**RANCH TOWN NO. 2 PUMP STATION IMPROVEMENTS PROJECT**  
**Solicitation No. CO-00599-LE**  
**Job No. 20-6005**

**ADDENDUM NO. 3**  
**October 21, 2022**

RANCH TOWN NO. 2 PUMP STATION IMPROVEMENTS  
ELECTRICAL SITE PLAN

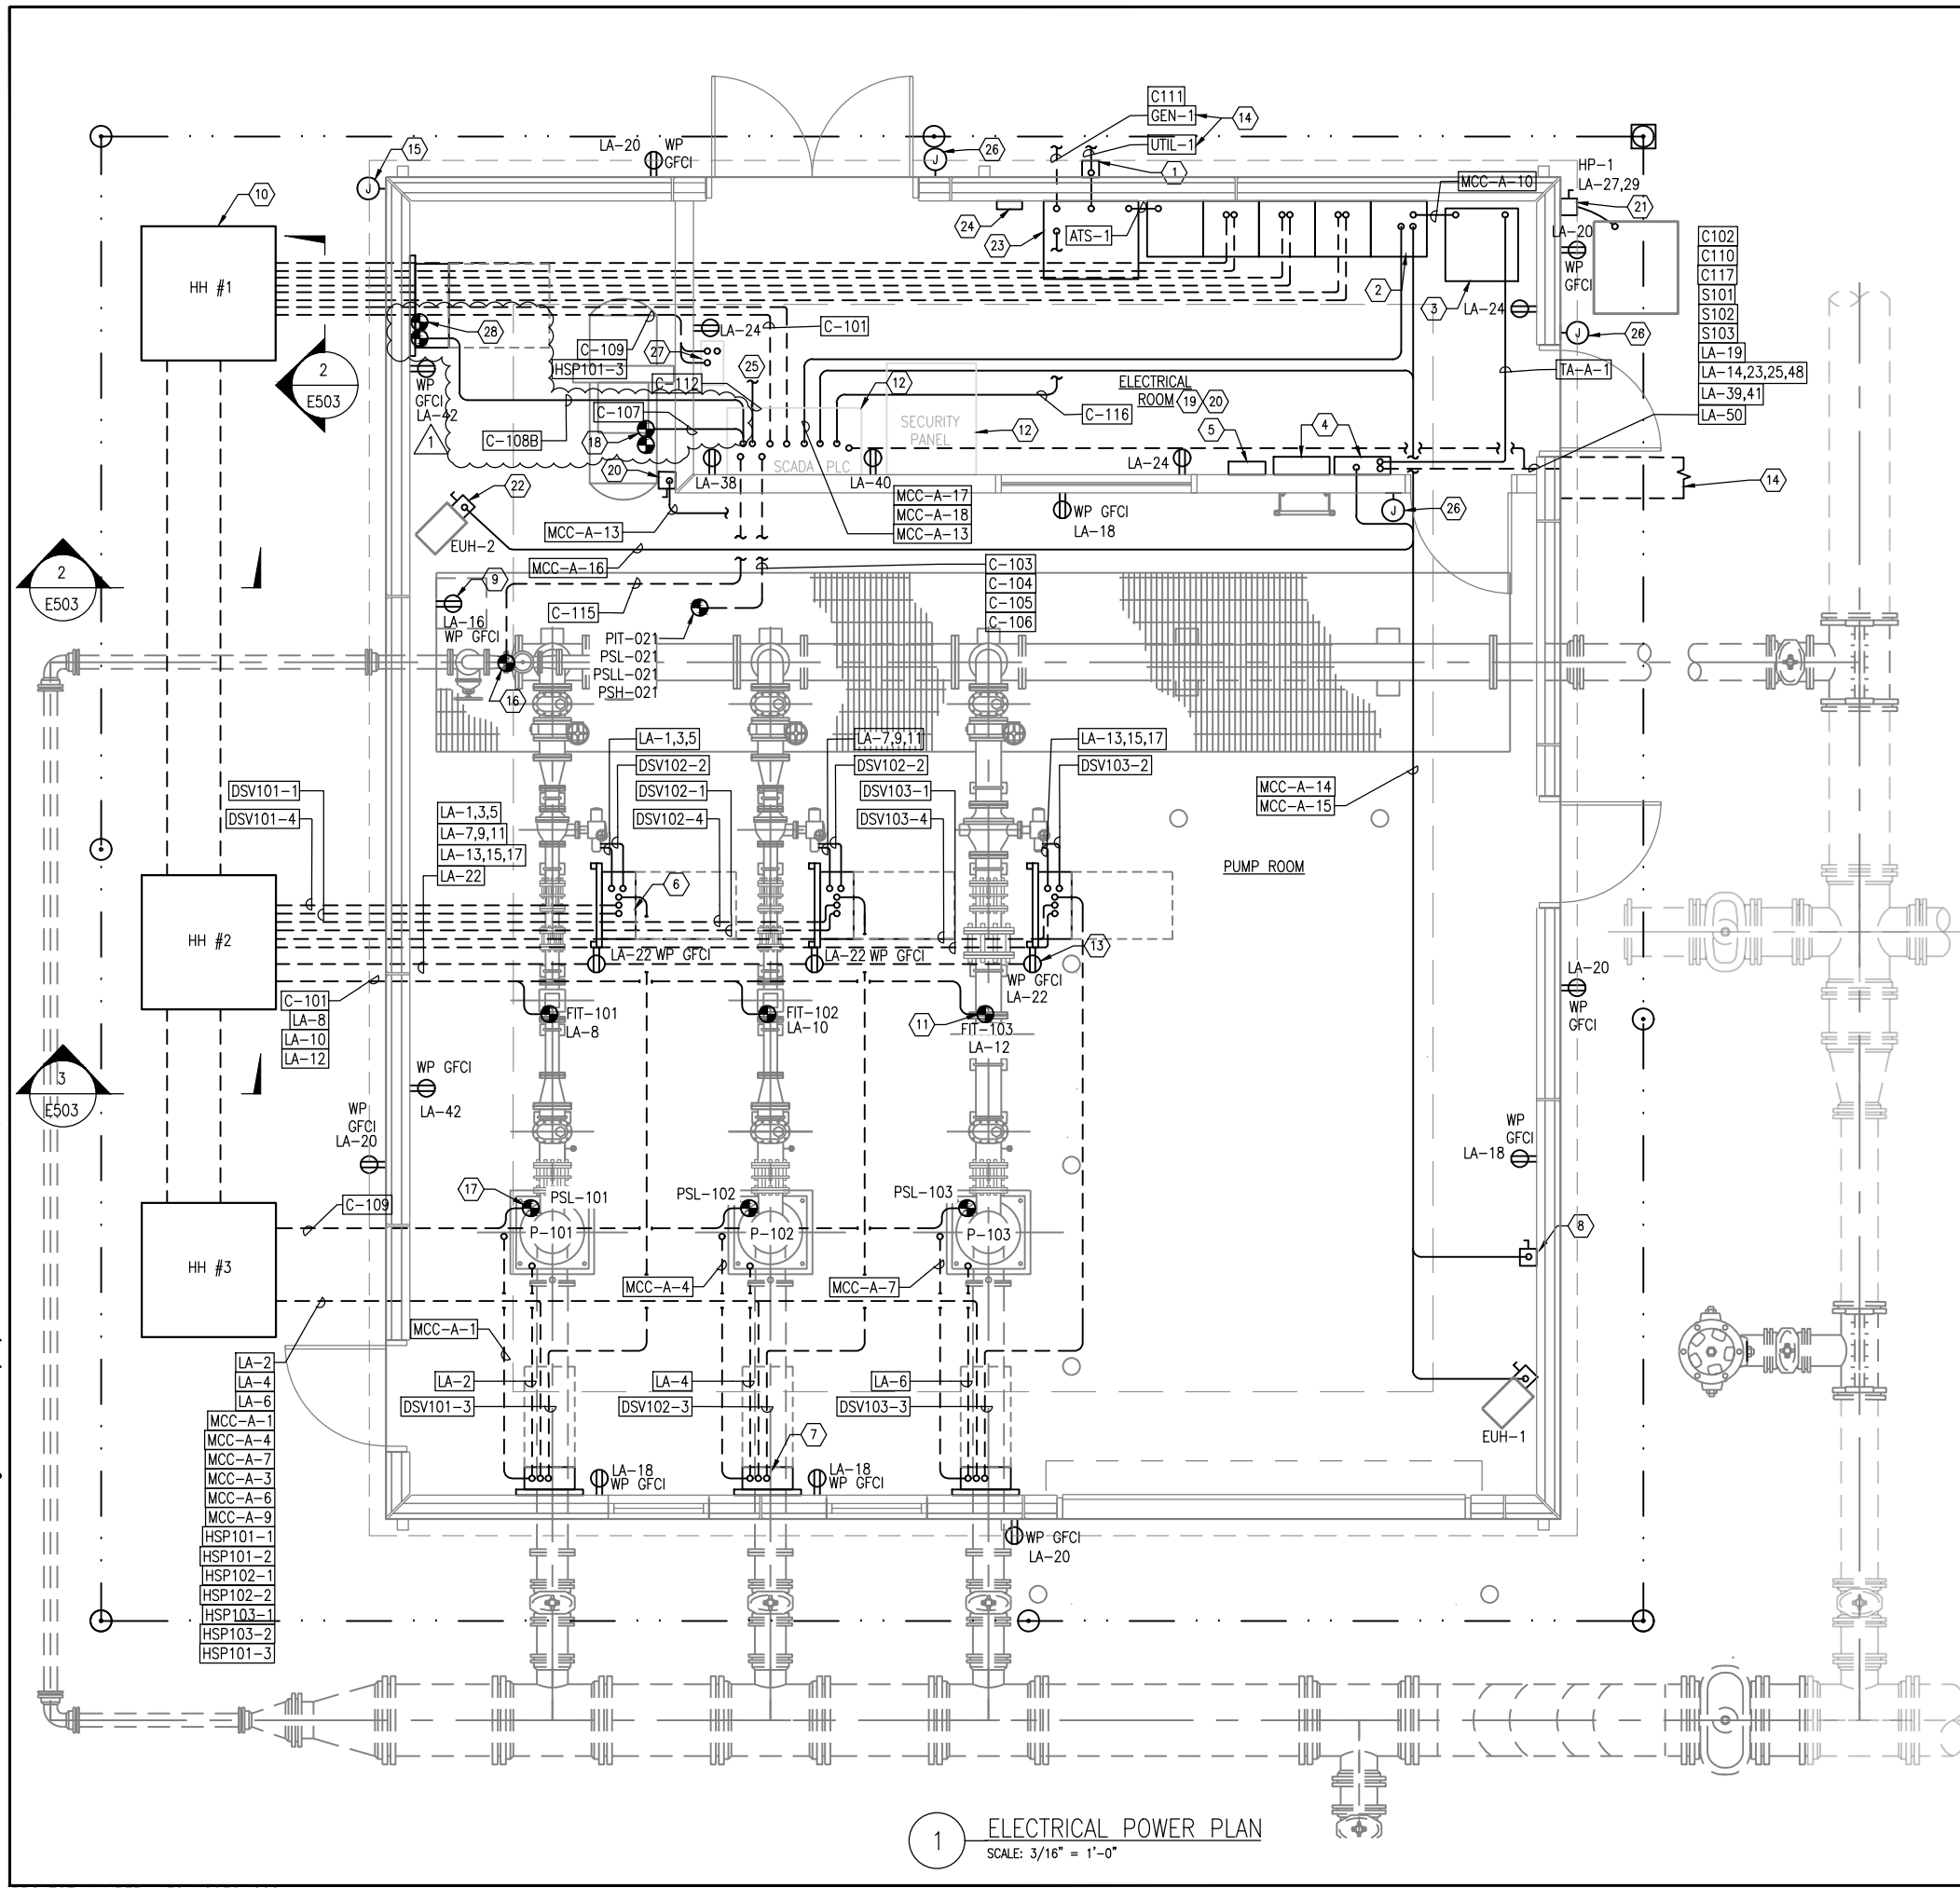
9. Question: Conduit/Circuit C-117 shows to be routed from LWCO Relay Panel to LSL-500 Ground Storage Tank Low Level switches to be mounted on Existing Water Storage tank. And currently routed to GST LIT-500, AIT-300 Rack in ductbank section. Please provide the routing from the Instrument Rack to the top of the GST. Currently there are no conduit routing available to the tank roof and it seems the only available routing to the roof will be via access ladder on the south side of the GST. It would seem routing this circuit to hand hole located on SW side of the GST with a short ductbank to the GST access ladder would be much more efficient. Please clarify routing intended.

10. Question: Sheet E503 duct bank sections 4 and 8 should show the security camera power circuits noted on keynote #14 on Sheet E102. Especially in ductbank section 8 as it is being routed to different location in the electrical room. Please review and advise.

16. Question: Sheet E102 Keynote 9 shows the requirements for the ground rod and bonding every 500' along the perimeter of the proposed fence, however it does not address Specification Section 26 05 26 3.5 C.8 b requiring protection at Crossing of Overhead Electrical Power Lines. Please clarify if this required.

*Response: Please refer to keynote 18 of the revised Sheet E102 - Electrical Site Plan, attached to this addendum. Refer to "Changes to the Plans", Item 1a.*

*Response: Please refer to keynote 14 of the revised Electrical Site Plan attached to this addendum. Refer to "Changes to the Plans", Item 1a.*

*Response: Please refer to Keynote 9 of the revised Sheet E102 - Electrical Site Plan, attached to this addendum. Refer to "Changes to the Plans", Item 1a.*

- BOND DUCTBANK GROUNDING COUNTERPOISE TO GROUND RINGS.
- PROVIDE GROUND ROD AND BOND EVERY 500FT ALONG PERIMETER OF PROPOSED FENCE. WHERE EXISTING OVERHEAD ELECTRICAL SERVICE CROSSES FENCE ENSURE GROUNDING OF FENCE DOES NOT ENCR OACH WITHIN 150FT ON EACH SIDE OF CROSSING. REFER TO CIVIL DRAWINGS FOR PROPOSED FENCING.

- FIELD VERIFY THE ROUTING OF THE EXISTING LEVEL PROBE CONDUIT AT TOP OF TANK. UTILIZE EXISTING ABOVE GRADE CONDUIT ON TANK FOR NEW LEVEL PROBE (LSL-500). INTERCEPT CONDUIT ABOVE GRADE AT BOTTOM OF TANK. PROVIDE A NEMA 4X JUNCTION BOX AT BOTTOM OF TANK AND PROVIDE A 1" BELOW GRADE CONDUIT TO THE CL ANALYZER / LEVEL TRANSMITTER RACKSTAND. FROM THE RACKSTAND ROUTE LSL-500 LEVEL CONDUCTORS BACK TO THE LWCO PANEL VIA CONDUIT C-117. PROVIDE A 3/4" CONDUIT FROM THE LWCO PANEL TO THE SCADA PANEL FOR TANK LEVEL LSL-500 AND PUMP LOW SUCTION ALARMS/POINTS.

1 ELECTRICAL DUCTBANK TYPICAL DETAIL  
SCALE: NTS

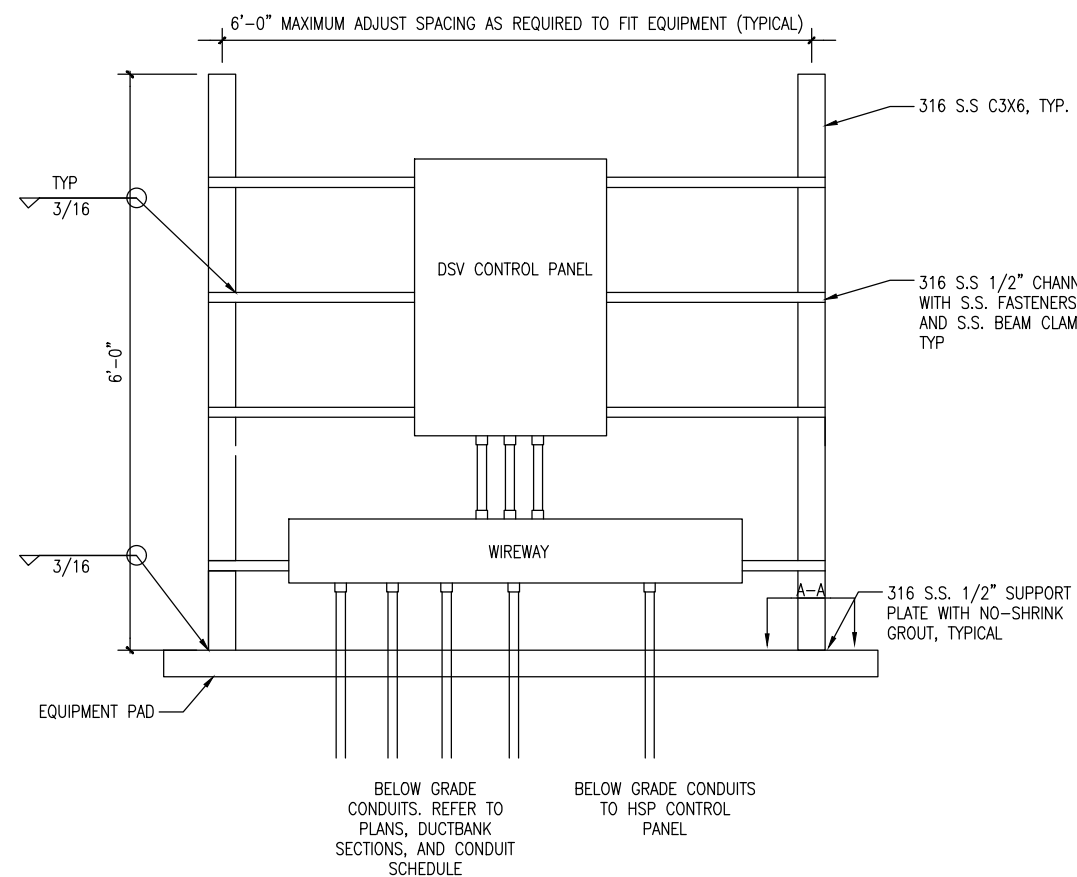
1. Question: Sheet E503 Detail 1 calls for width of the ductbank concrete to be minimum of 18-1/4" Deep and 2'-10" Wide. This would result in considerably large concrete envelop around the conduits particularly in duct banks that have 2x2 and 1 x 3 conduit orientations. Please confirm if the typical requirements are intended for all duct banks.

*Response: Duct bank detail is typical representation of a 6-conduit duct bank. Refer to "Changes to the Plans", Item 1c.*

- NOTES:
- DUCTBANK DETAIL IS TYPICAL REPRESENTATION OF A 6-CONDUIT DUCT BANK. ENVELOPE DIMENSIONS 18-1/4" X 2-10" ARE APPLICABLE ONLY TO THE CONDUIT CONFIGURATION AS SHOWN. ALL DUCT BANKS SHALL MAINTAIN A MINIMUM 3" SEPARATION BETWEEN CONDUITS AND A 2-1/4" ENVELOPE ON EACH SIDE OF DUCTBANK. TOP OF DUCT BANK A MINIMUM OF 6" OF CONCRETE TO FIRST ROW OF CONDUITS.
  - CONDUIT TO BE RIGID NON-METALLIC TYPE FOR CONCRETE ENCASMENT, SIZE AND NUMBER AS INDICATED ON DRAWINGS, SECTION DETAILS, AND CONDUIT SCHEDULE.
  - CONCRETE ENCASMENT: ALL CONCRETE TO HAVE COMPRESSIVE STRENGTH OF 2500 P.S.I. AT 28 DAYS. NO AGGREGATE LARGER THAN 3/4".
  - INSTALL SPACERS EVERY 5 FEET. ALL SPACERS TO PROVIDE 3" VERTICAL AND HORIZONTAL SEPARATION BETWEEN CONDUITS.
  - SUBGRADE SHALL BE COMPACTED TO 90% DENSITY AND WITH +3% TO -3% OF OPTIMUM MOISTURE STANDARD ASTM D698. COMPACT BACKFILL IN 6 INCH LIFTS.

1 ELECTRICAL ONE-LINE DIAGRAM SCALE: NTS

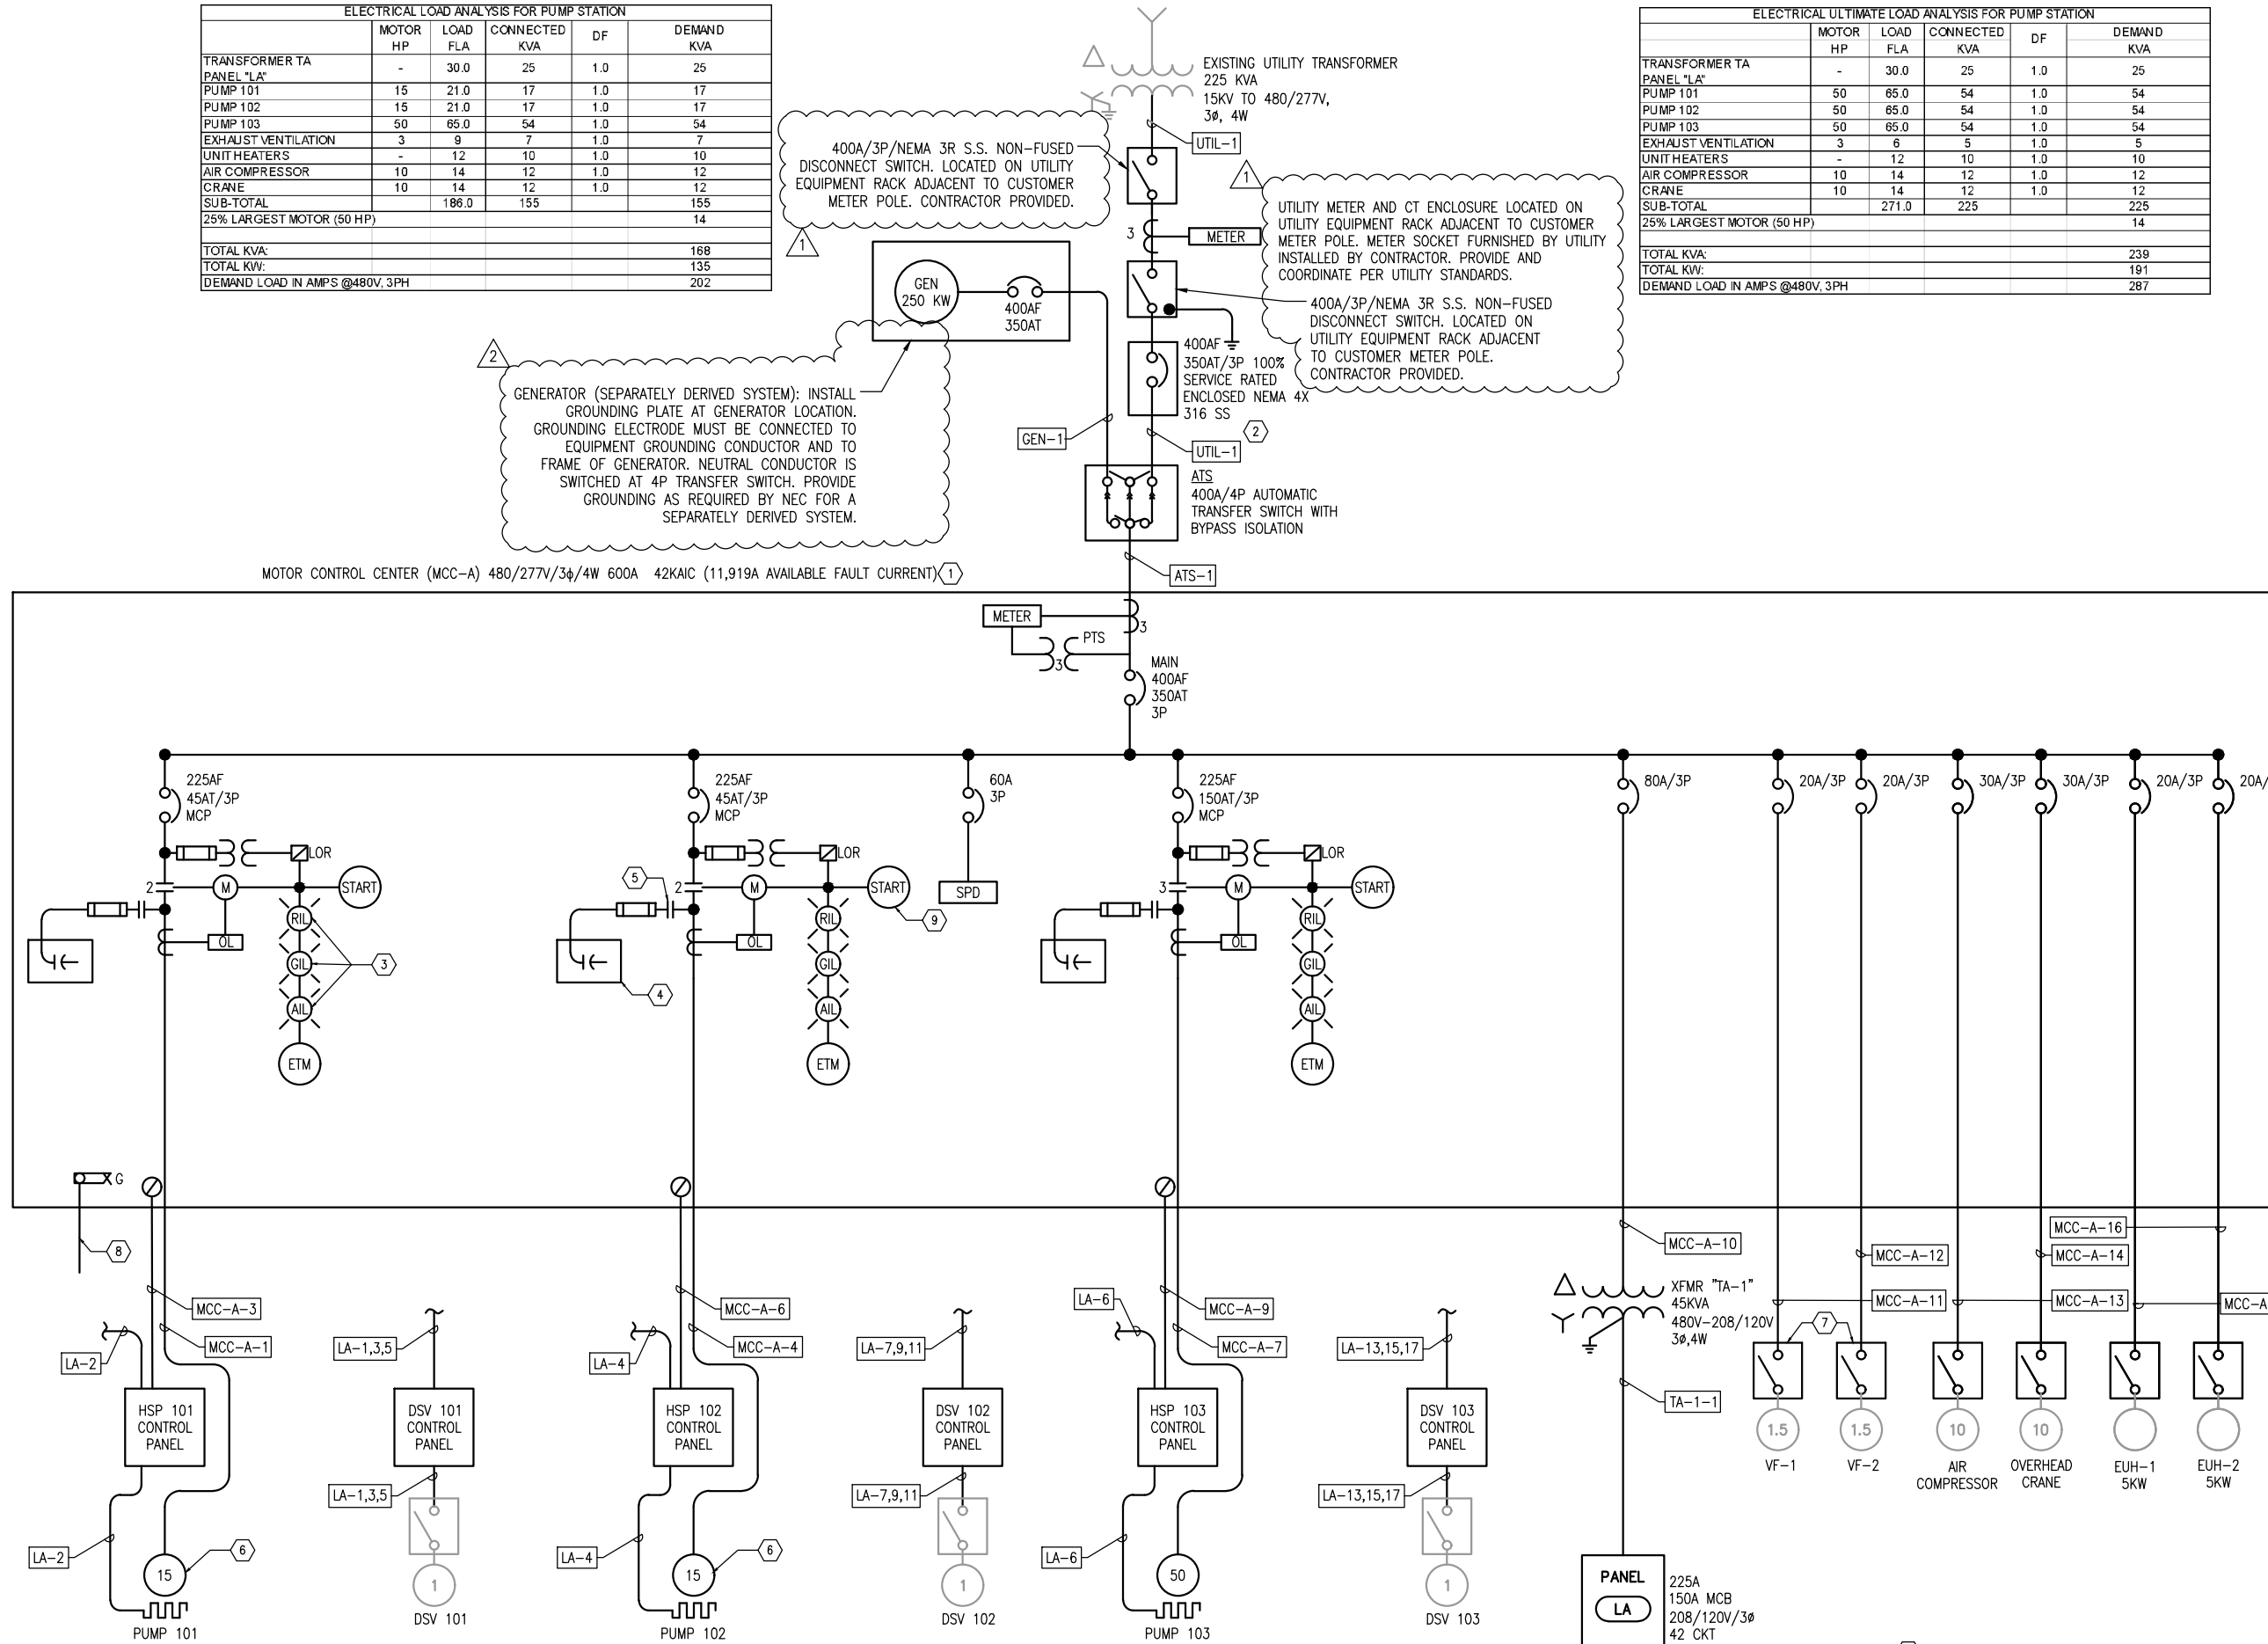
15. Question: Plan drawings does not show the grounding for the Emergency Generator as specified in Specification Section 26 05 26 3.5 C.5 a. Please provide grounding plans & details.

*Response: Please refer to revised Sheet E601 - One-Line Diagram, attached to this addendum. Refer to "Changes to the Plans", Item 1d.*

GENERATOR (SEPARATELY DERIVED SYSTEM): INSTALL GROUNDING PLATE AT GENERATOR LOCATION. GROUNDING ELECTRODE MUST BE CONNECTED TO EQUIPMENT GROUNDING CONDUCTOR AND TO FRAME OF GENERATOR. NEUTRAL CONDUCTOR IS SWITCHED AT 4P TRANSFER SWITCH. PROVIDE GROUNDING AS REQUIRED BY NEC FOR A SEPARATELY DERIVED SYSTEM.

1 CHLORINE ANALYZER AND LEVEL TRANSMITTER RACKSTAND  
SCALE: NTS

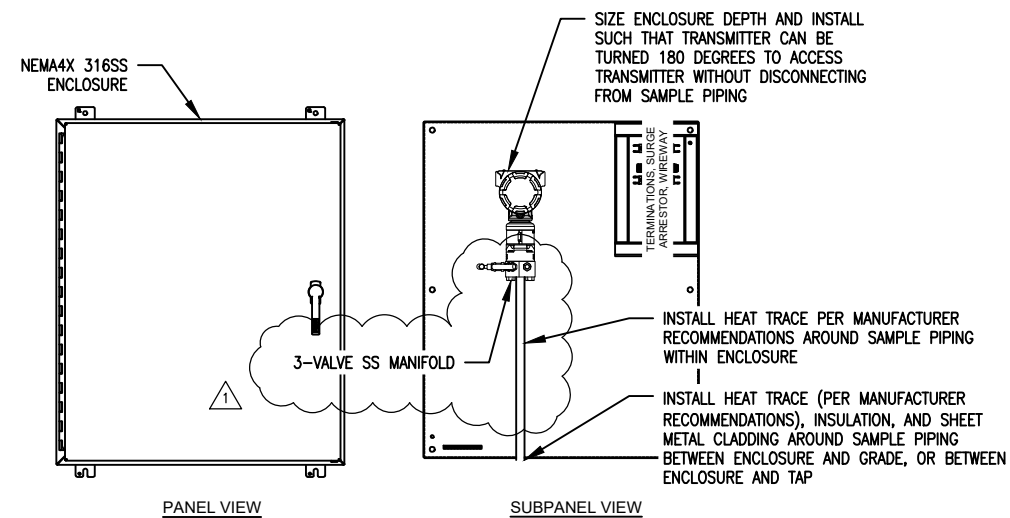
7. Question: Detail 1 on sheet N503 calls for 316SS Backplate for the GST instrument rack backplate, SAWS standards for rack back plate is Aluminum Plate. Please confirm the use of Aluminum back plate is acceptable.

*Response: The backplate may be aluminum so long as the dissimilar metals are insulated properly. Refer to "Changes to the Plans", Item 1f.*
